Belmont Bridge Replacement

Board Of Architectural Review Meeting

August 15, 2017

BAR 17-08-02

Corridor Site Furnishings

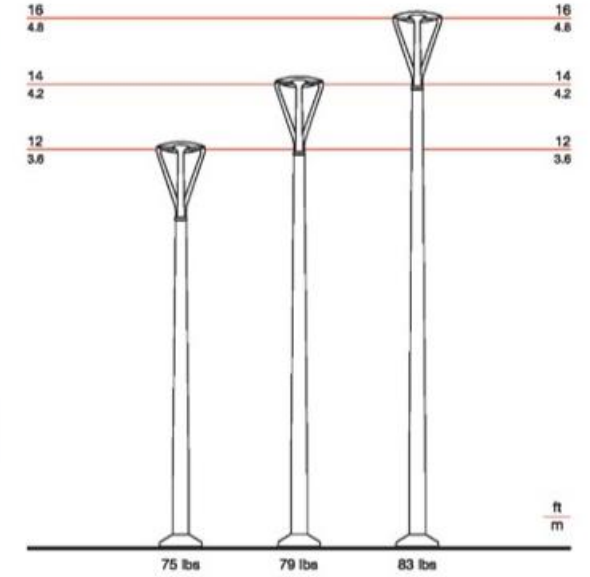
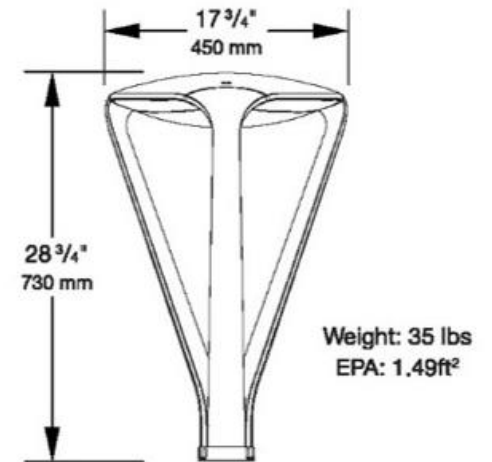
- **The furniture color must be black like the Mall street furniture. Furniture could be more creative design, but must fit more into the design and character of the Downtown ADC.**

CSX Fencing

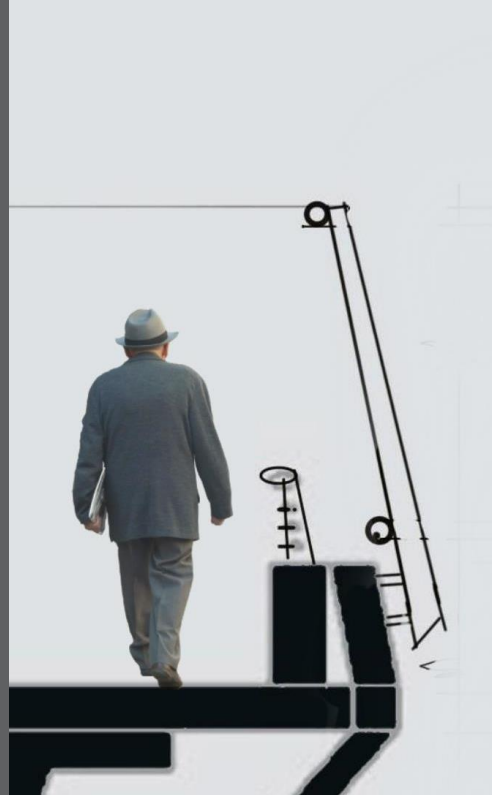
- **The combination of landscaping, engineering, and planning is going in the right direction, but there needs to be more cohesion and an overall design philosophy. The seat walls, rails and lighting seem too disparate. CSX screen needs to be integrated more.**

Green Screen

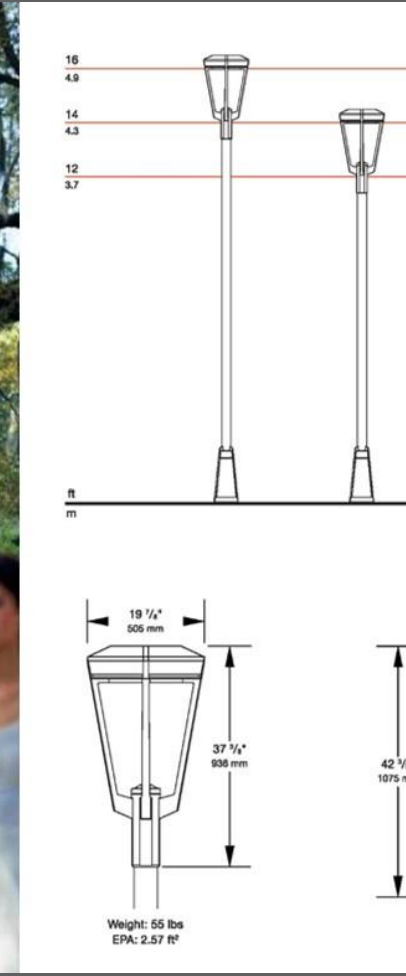
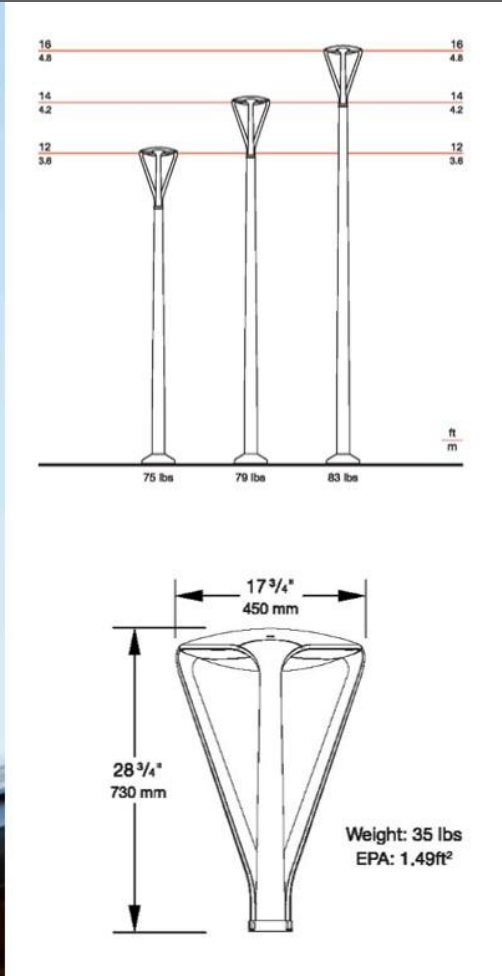
- **Reduce the amount of concrete with more stone, wood, green space, planters, or possibly different materials such as xeriscape gravel. Green screens may not survive the hot and exposed locations.**

Pedestrian Circulation South of Railroad

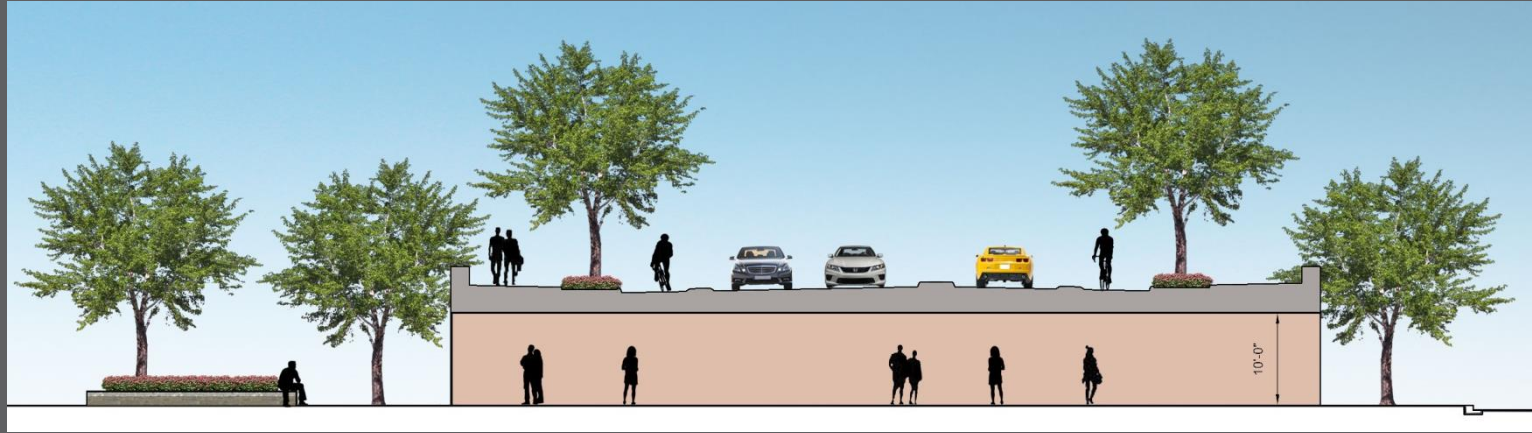
- **Supportive on the tunnel underpass, but wished the circulation was more fluid in the design; streamline approach to it.**
- **Keep pedestrian crosswalk for now until future development changes current pedestrian patterns.**
